Bidding and Contract Requirements
Addendum No. 3

Subject: Addendum No. 3 to the Bidding Documents for:

ILEAS Air Handling Unity Replacement (2026-001)
County of Champaign
Urbana, Illinois

LARGE SCALE HEATING - BASEMENT MECHANICAL ROOM

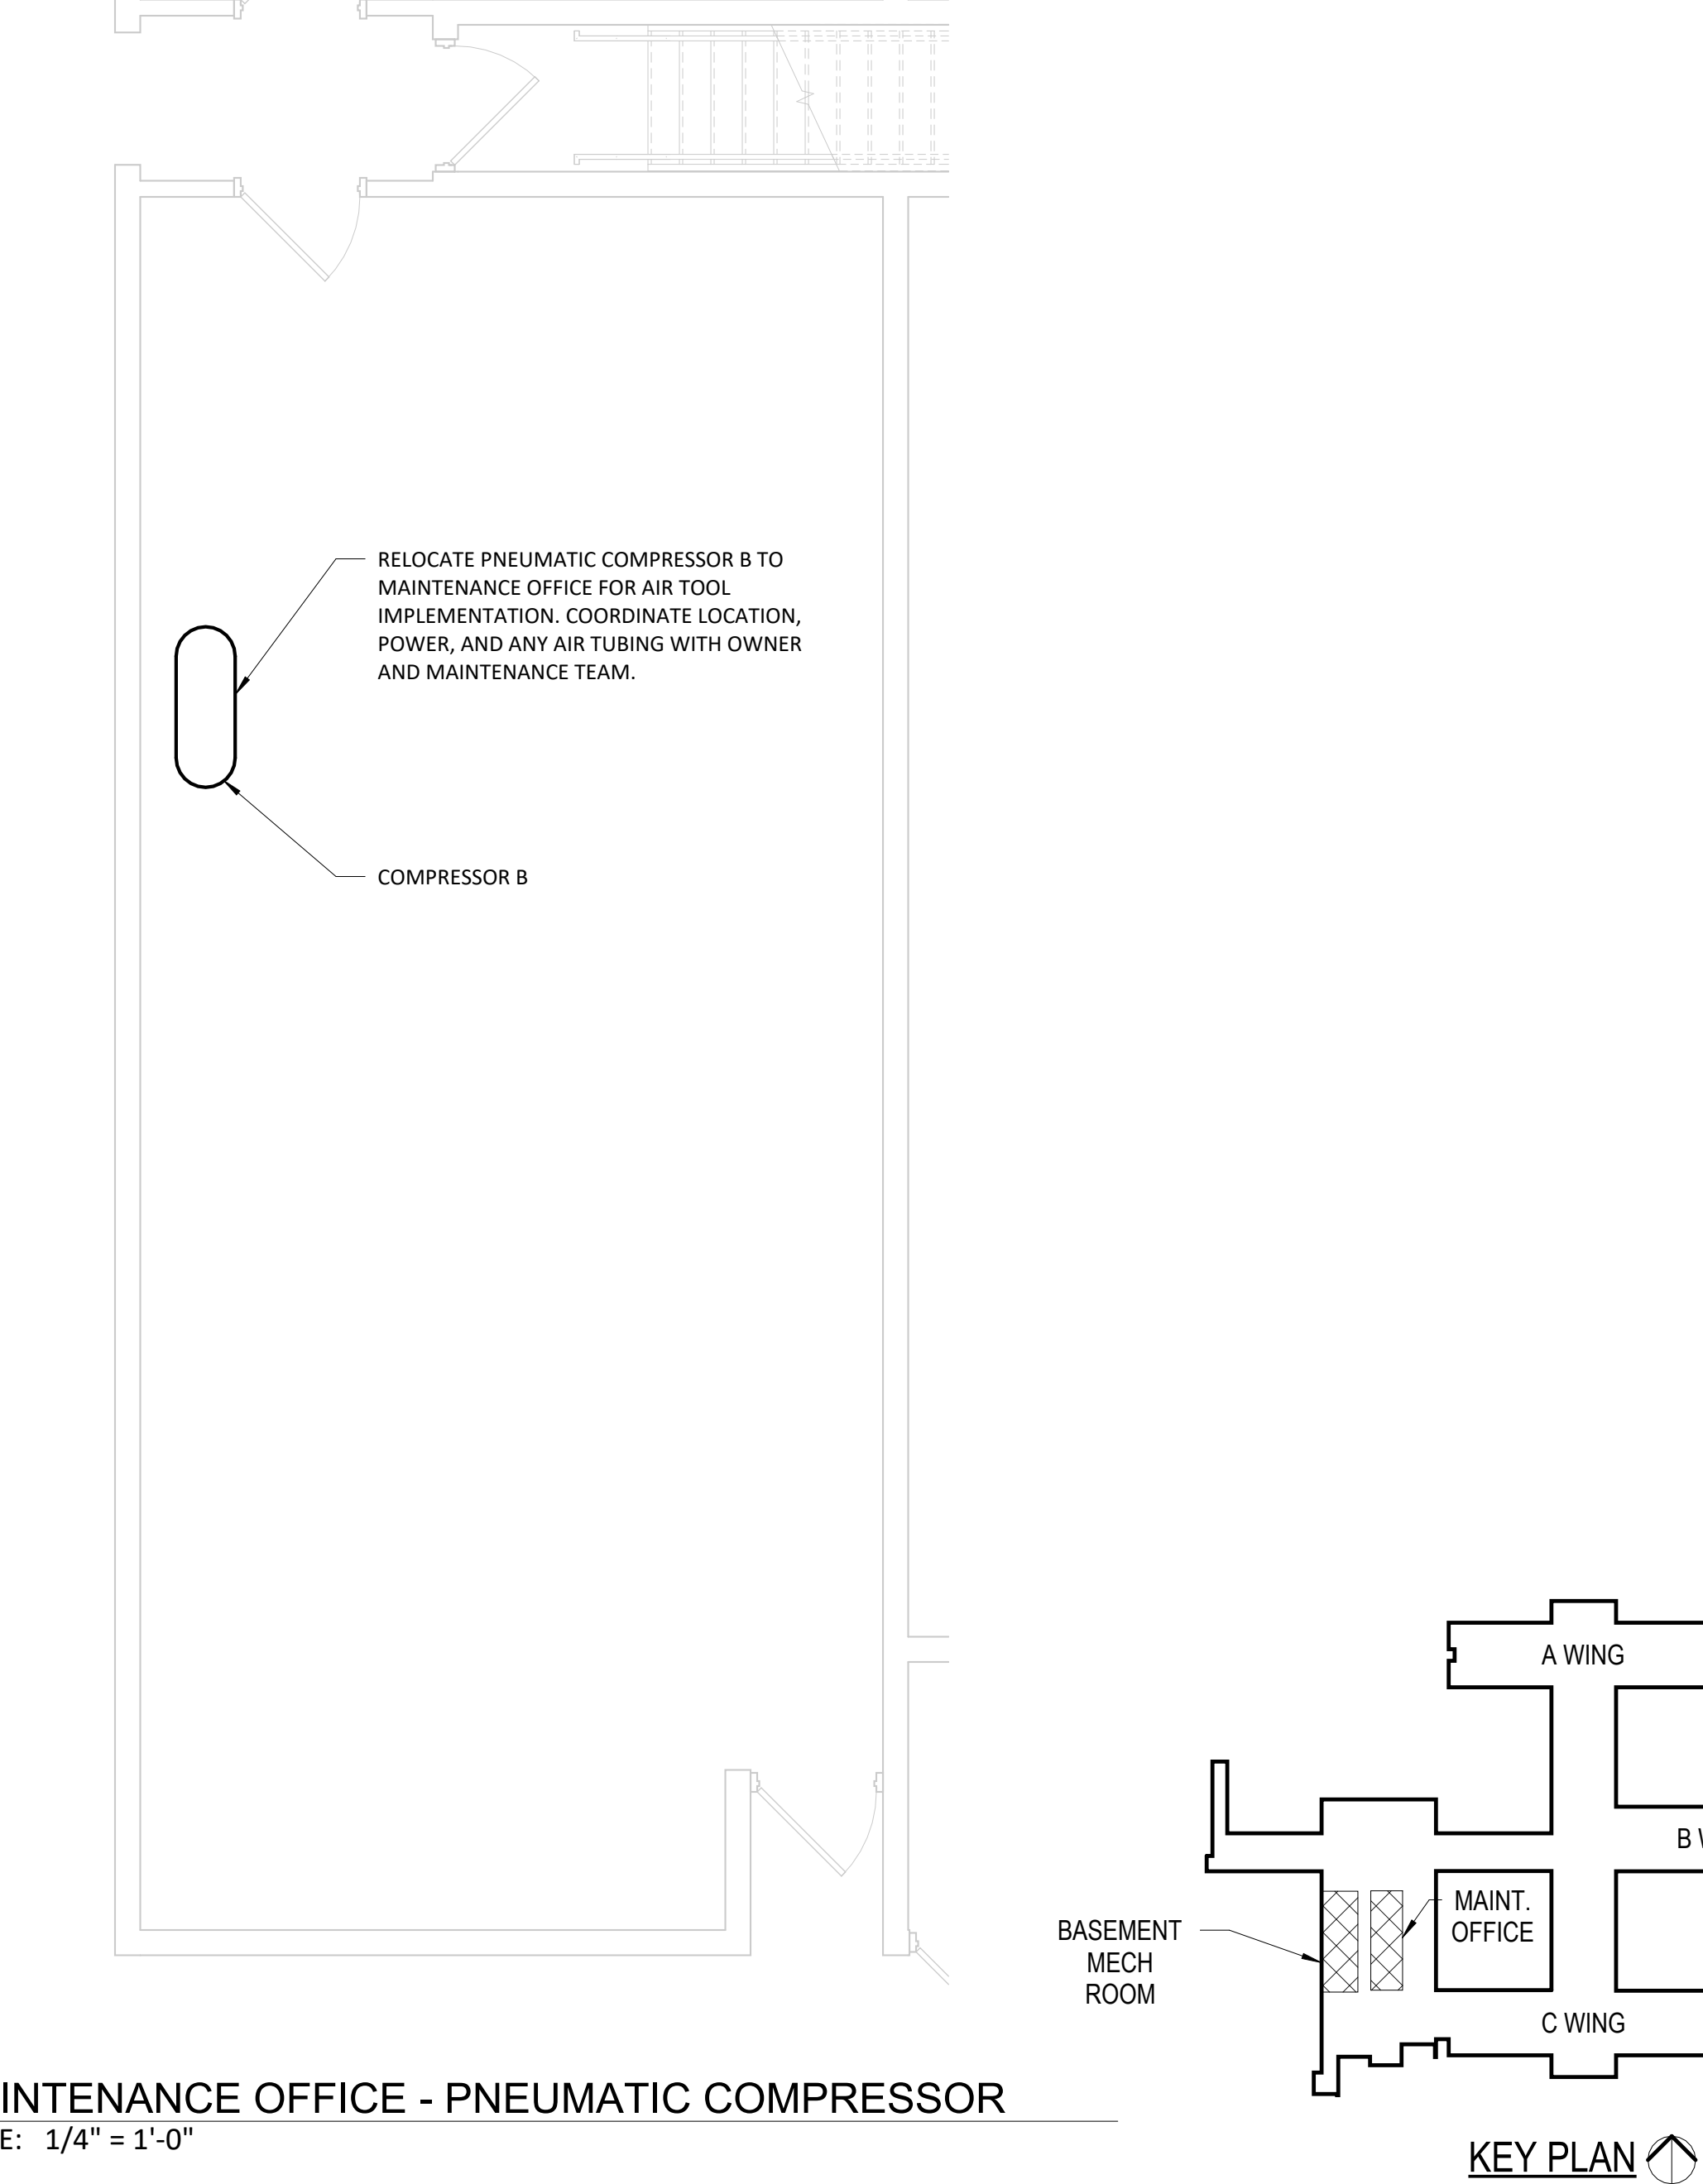
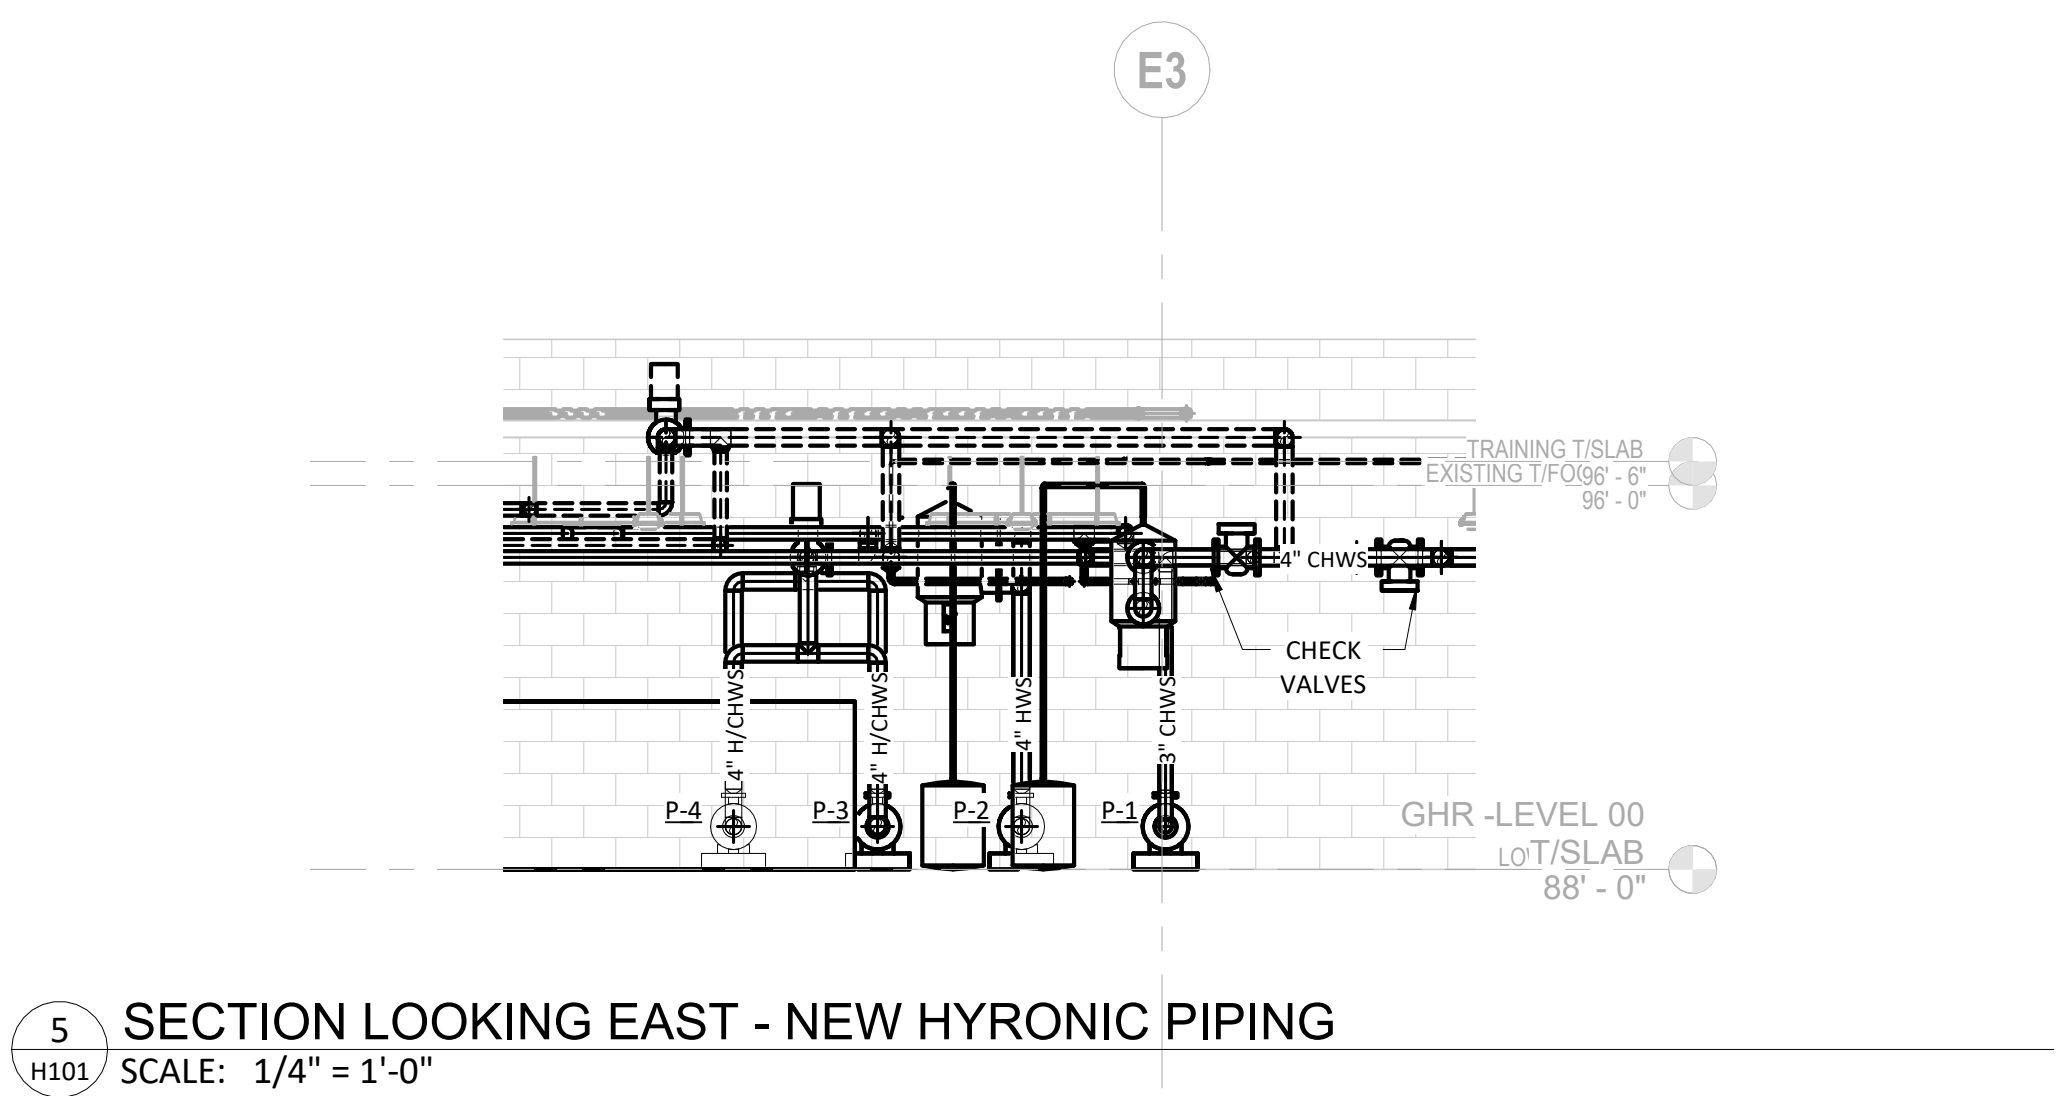
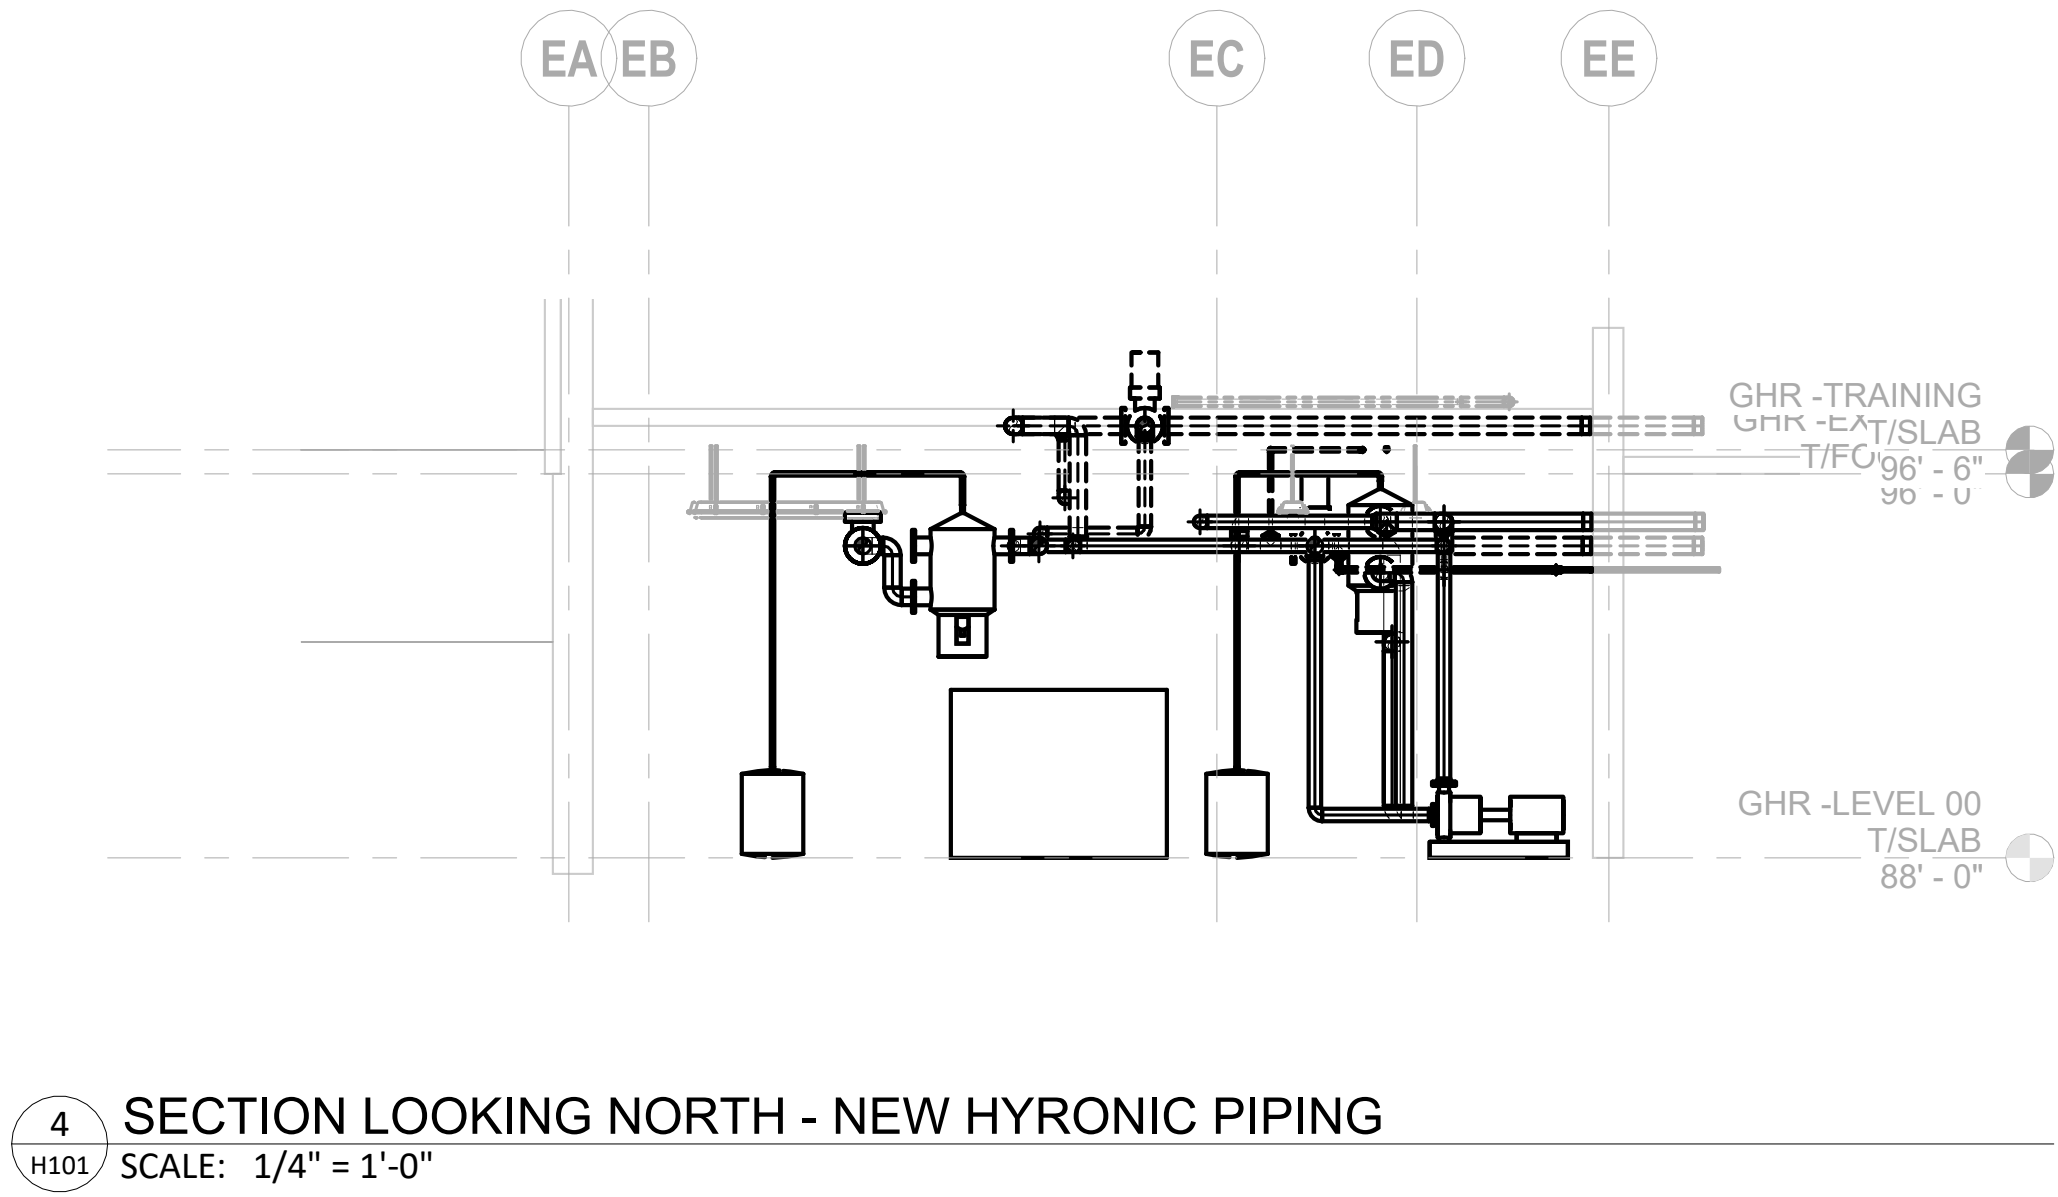
1. Sheet H101 - Large Scale Heating - Basement Mechanical Room
 - a. REVISED orientation of AHU-2 to run N-S.
 - b. REVISED piping to AHU-2 per the re-orientation.
2. Sheet VD101 - Large Scale Ventilation Demolition - Basement Mechanical Room
 - a. Sheet VD101 - Large Scale Ventilation Demolition - Basement Mechanical Room
3. Sheet V101 - Large Scale Ventilation - Basement Mechanical Room
 - a. REVISED orientation of AHU-2 to run N-S.
 - b. REVISED ductwork to AHU-2 per the re-orientation.
4. Sheet HV200 - Schedules and Details - Mechanical
 - a. REVISED AHU schedule notes to better coordinate housekeeping pad instructions with existing obstructions and to better serve the re-oriented
